SUBJECT: COMANCHE PEAK NUCLEAR POWER PLANT, UNITS 3 AND 4
DOCKET NUMBERS 52-034 AND 52-035
RESPONSE TO REQUEST FOR ADDITIONAL INFORMATION NO. 5755
(SECTION 14.3.7)

RAI NO.: 5755 (CP RAI #220)

SRP SECTION: 14.03.07 - Plant Systems - Inspections, Tests, Analyses, and Acceptance Criteria

Figure 9.4-203 UHS ESW Pump House Ventilation Systems Flow Diagram

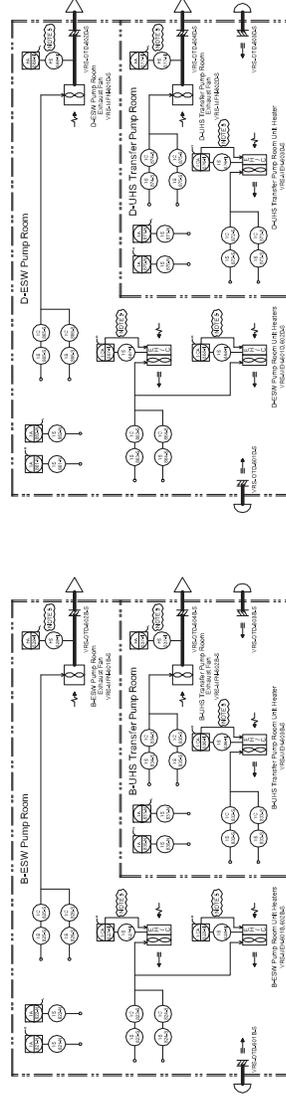
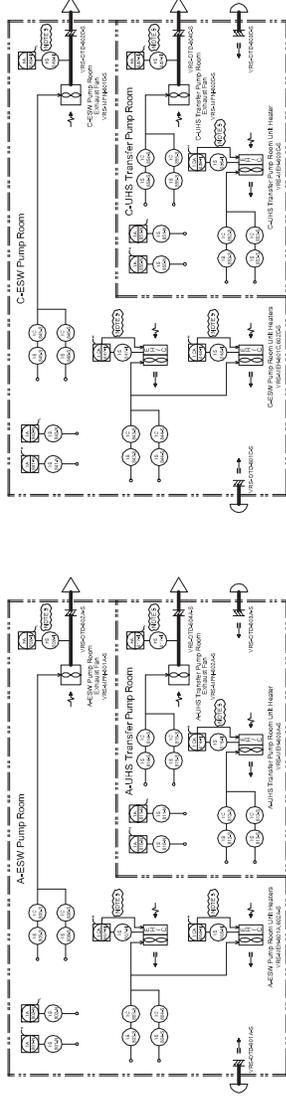
The staff also notes that the temperature and flow instrumentation attached to the room heaters and exhaust fans would be classified as seismic category II (as a minimum threshold with respect to plant safety). The staff requests additional information about the seismic classification and about the basis for the classification of all instrumentation (i.e. including alarm temperature switches) displayed in Figure 9.4-201 and that the applicant update as necessary FSAR Tables 3.2-201 and A.2-2.

All the instrumentation displayed in FSAR Revision 1 Figure 9.4-201 (FSAR Draft Revision 2 Figure 9.4-203) is designed in accordance with DCD Subsection 3.2.1. The non-safety related temperature and flow instrumentation attached to the unit heaters and exhaust fans is classified as seismic category II in accordance with the design bases described in DCD Subsection 3.2.1. Figure 9.4-201 has been revised to add a note that the non-safety related instrumentation attached to the unit heaters and exhaust fans is classified as seismic category II. Table A.2-2 addresses only safety-related equipment. Consistent with DCD Table 3.2-2, FSAR Table 3.2-201 does not list specific instruments. Therefore, no update is necessary for Table A.2-2 or Table 3.2-201 to include non-safety related instrumentation.

See attached marked-up FSAR Draft Revision 2 Figure 9.4-203.
